SAFETY ALERT

DATE: July 28, 2003

SUBJECT: Back Up Wrench Cylinder Clevis Backing Out

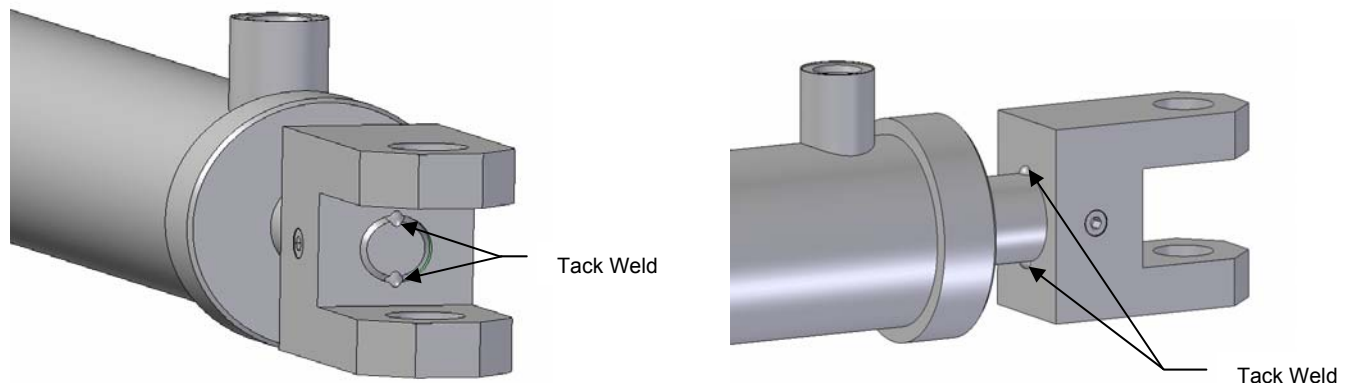
DISCUSSION: It has been reported that the Back-Up Wrench Cylinder rod is coming loose from the clevis; thus allowing the inner tube assembly to drop. It appears that the setscrew that prevents the cylinder rod from rotating had come loose and allowed the rod to unscrew off the clevis.

If the clevis is loose and the setscrew can not keep it tight, follow the procedure below to help retain the clevis onto the rod. The BUW will have to be disassembled and the clevis has to be properly tightened to the rod prior to any welding.

To prevent the cylinder rod from rotating against the clevis and coming loose, it is recommended that a **"TACK WELD"** be applied to the clevis and the cylinder rod as shown in the figures below. The tack weld length must be 0.25 to 0.5" long. Low Hydrogen welding rods 11018 or 7018 must be used for this tack welding. Pre-heating and post heating are not required when tack welding.
